TSG RAN Meeting #21   **RP-030417**
Frankfurt, Germany, 16 - 19 September 2003

Title   **CRs (Rel-5 and Rel-6 Category A) to TS 25.101 under WI "High Speed Downlink Packet Access"**

⌘   **25.101 CR 250**   ⌘**rev 3** ⌘   Current version: **5.7.0** ⌘

Title: ⌘	Addition of transmitter characteristics for HS-DPCCH	
Source: ⌘	RAN WG4	
Work item code: ⌘	HSDPA-RF	***Date:*** ⌘ 08/09/2003

Figure 6.5A: Transmit template during Ack/Nack transmission

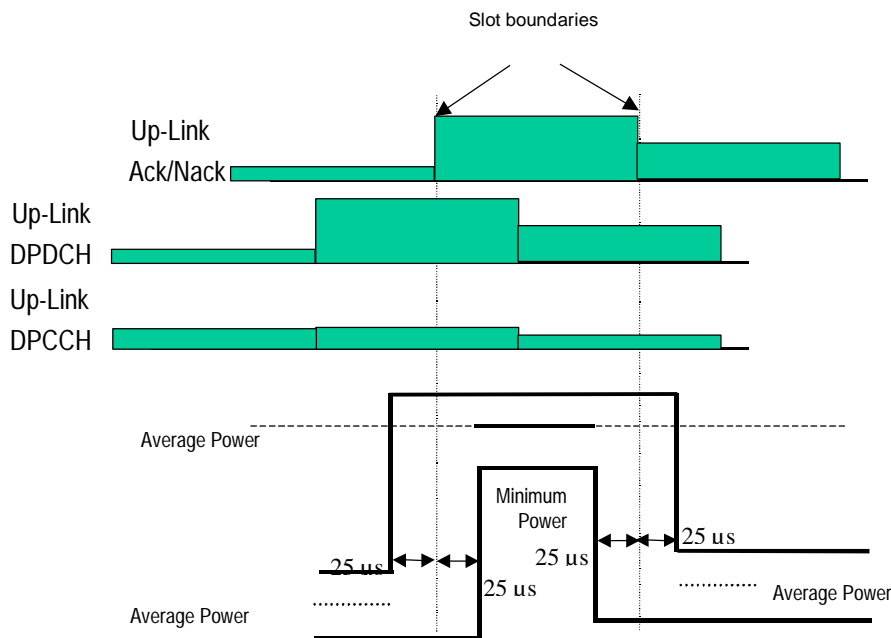
Reason for change: ⌘	Transmitter power step torelance requirements with HS-DPCCH are missing.
Summary of change: ⌘	The power step torelance requirements with HS-DPCCH are added.
Consequences if not approved: ⌘	Transmitter power step torelance requirements with HS-DPCCH are missing.

A change of output power is required when Ack/Nack or CQI is transmitted. The ratio of the amplitude between the DPCCH and the Ack/Nack and CQI respectively is signalled by the higher layers. The sum power on DPCCH+DPDCH shall not change by the transmission of Ack/Nack and CQI unless UE output power when Ack/Nack or CQI is transmitted would exceed the maximum allowed value whereupon the UE shall apply additional scaling to the total transmit power as defined in section 5.1.2.6 of TS.25.214. The sum in total transmitted power (DPCCH + DPDCH+HS-DPCCH) shall then be rounded to the closest integer dB value. A power step exactly half-way between two integer values shall be rounded to the closest integer of greater magnitude. The accuracy of the power step, given the step size, is specified in Table 6.9A. The power change due to transmission of Ack/Nack or CQI is defined as the relative power difference between the mean power of the original (reference) timeslot and the mean power of the target timeslot, not including the transient duration. The transient duration is from 25µs before the HS-DPCCH slot boundary to 25µs after the HS-DPCCH slot boundary.

The transmit power levels versus time shall meet the mask specified in Figure 6.x.

Figure 6.5A: Transmit template during Ack/Nack transmission

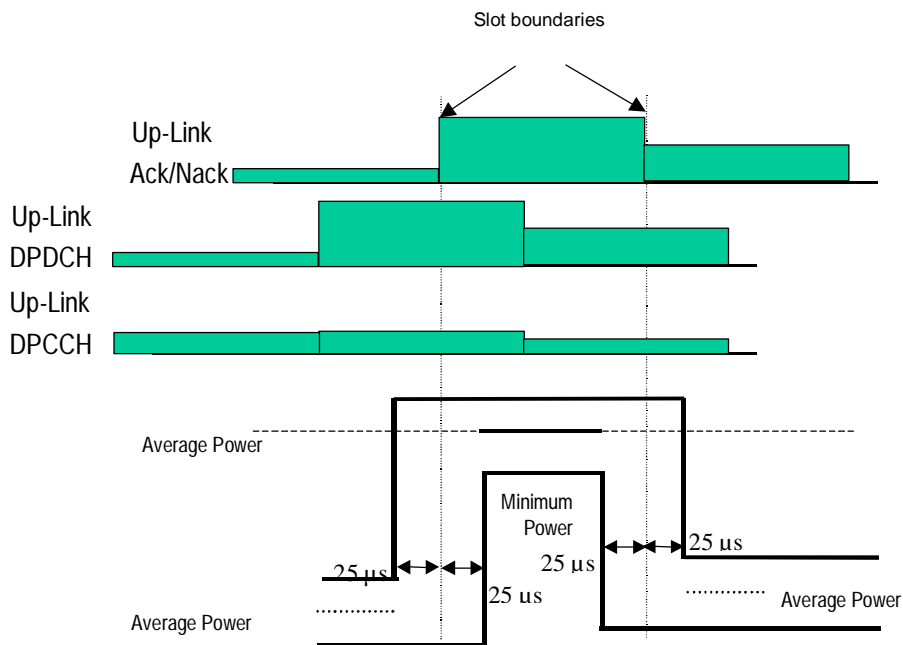
Reason for change:	⌘	Transmitter power step torelance requirements with HS-DPCCH are missing.

Summary of change:	⌘	The power step torelance requirements with HS-DPCCH are added.

A change of output power is required when Ack/Nack or CQI is transmitted. The ratio of the amplitude between the DPCCH and the Ack/Nack and CQI respectively is signalled by the higher layers. The sum power on DPCCH+DPDCH shall not change by the transmission of Ack/Nack and CQI unless UE output power when Ack/Nack or CQI is transmitted would exceed the maximum allowed value whereupon the UE shall apply additional scaling to the total transmit power as defined in section 5.1.2.6 of TS.25.214. The sum in total transmitted power (DPCCH + DPDCH+HS-DPCCH) shall then be rounded to the closest integer dB value. A power step exactly half-way between two integer values shall be rounded to the closest integer of greater magnitude. The accuracy of the power step, given the step size, is specified in Table 6.9A. The power change due to transmission of Ack/Nack or CQI is defined as the relative power difference between the mean power of the original (reference) timeslot and the mean power of the target timeslot, not including the transient duration. The transient duration is from 25µs before the HS-DPCCH slot boundary to 25µs after the HS-DPCCH slot boundary.

The transmit power levels versus time shall meet the mask specified in Figure 6.x.
